Contract #: 04-0120F4Cty: SF/ALA Rte: 80 PM: 13.2/13.9File #: 69.25B**QUALITY ASSURANCE -- NON-CONFORMANCE REPORT****Location:** Changxing Island, Shanghai, P.R. China**Report No:** NCR-000664**Prime Contractor:** American Bridge/Fluor Enterprises, a JV**Date:** 29-Jan-2010**Submitting Contractor:** Zhenhua Port Machinery Company, Ltd (ZPMC), Changxing Island**NCR #:** ZPMC-0634**Type of problem:**

Reference Description: Missed Class A UT indication on Deck Panel Splice, 8CE**Description of Non-Conformance:**

Job Name: SAS Superstructure

Subject: NCR No. ZPMC-0634

WELD NUMBER: SEG3002A-001

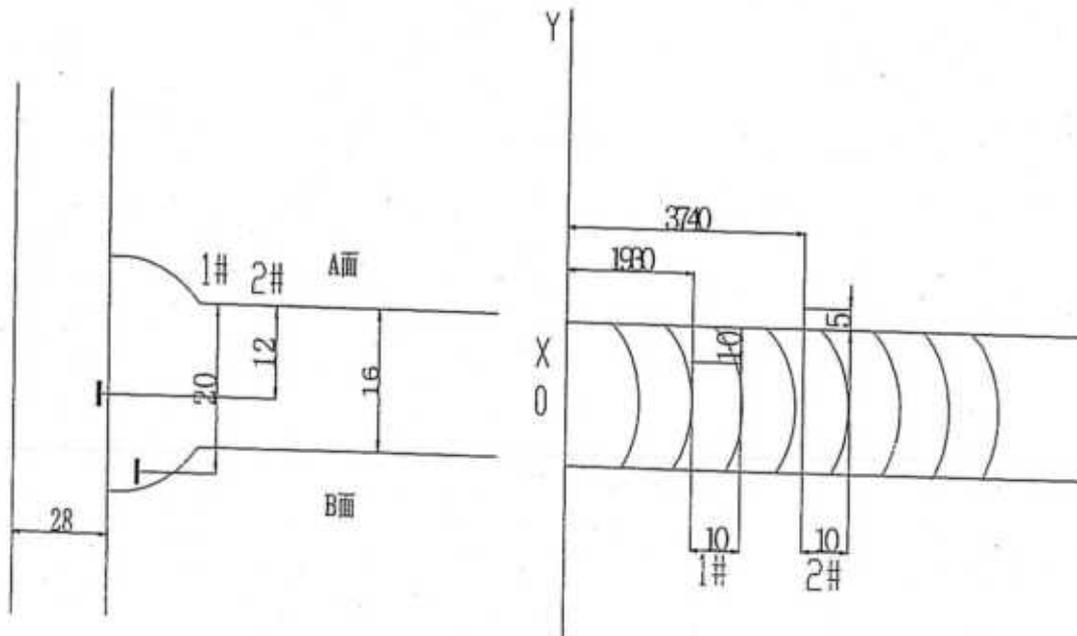
Description of welding discontinuity:

Rejected indication found by ultrasonic inspection is less than the maximum allowance aggregate length.

(UT探伤发现的缺陷总长度小于最大允许长度。) SEG3002A-001

1. Gouge or grind from nearer side from metal edge ($D \leq 0.65T$, "D" is depth of defects, "T" is thickness of metal) to remove all defects;

2. Follow repair WPS for joint preparation, preheat, and weld deposit;

3. Verify with VT no defects remain in the weld joint prior to welding;

4. Grind the repaired area flush with base metal or the adjacent weld;

5. Perform UT inspection to the weld along with 50mm on each end of the repair area;

WELD NUMBER: SEG048*-008

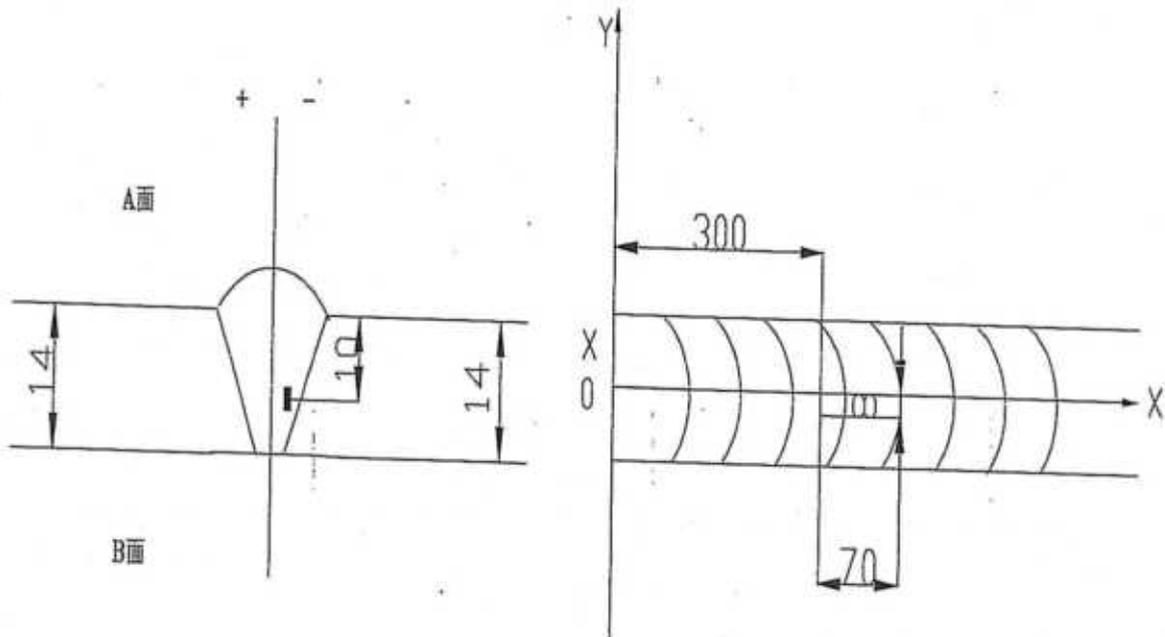
Description of welding discontinuity:

Rejected indication found by ultrasonic inspection is less than the maximum allowance aggregate length.

(UT探伤发现的缺陷总长度小于最大允许长度。) SEG048*-008

1. Gouge or grind from nearer side from metal edge ($D \leq 0.65T$, "D" is depth of defects, "T" is thickness of metal) to remove all defects;
2. Follow repair WPS for joint preparation, preheat, and weld deposit;
3. Verify with VT no defects remain in the weld joint prior to welding;
4. Grind the repaired area flush with base metal or the adjacent weld;
5. Perform UT inspection to the weld along with 50mm on each end of the repair area;

(UT探伤发现的缺陷总长度小于最大允许长度。) SEG050A-003

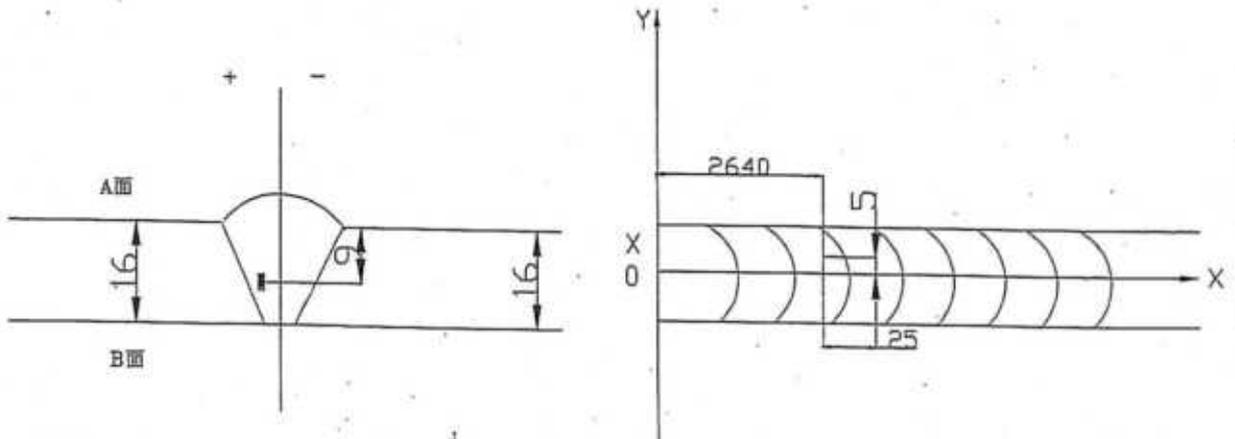
Description of welding discontinuity:

Rejected indication found by ultrasonic inspection is less than the maximum allowance aggregate length.

1. Gouge or grind from nearer side from metal edge ($D \leq 0.65T$, "D" is depth of defects, "T" is thickness of metal) to remove all defects;
2. Follow repair WPS for joint preparation, preheat, and weld deposit;
3. Verify with VT no defects remain in the weld joint prior to welding;
4. Grind the repaired area flush with base metal or the adjacent weld;
5. Check the welds according to the working drawings;

(UT探伤发现的缺陷总长度小于最大允许长度。) SEG050A-003

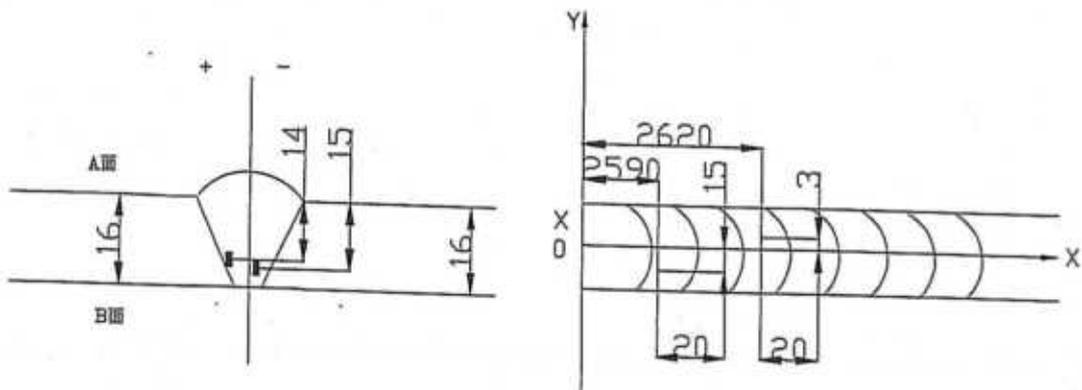
Description of welding discontinuity:

Rejected indication found by ultrasonic inspection is less than the maximum allowance aggregate length.

1. Gouge or grind from nearer side from metal edge ($D \leq 0.65T$, "D" is depth of defects, "T" is thickness of metal) to remove all defects;

3. Verify with VT no defects remain in the weld joint prior to welding;
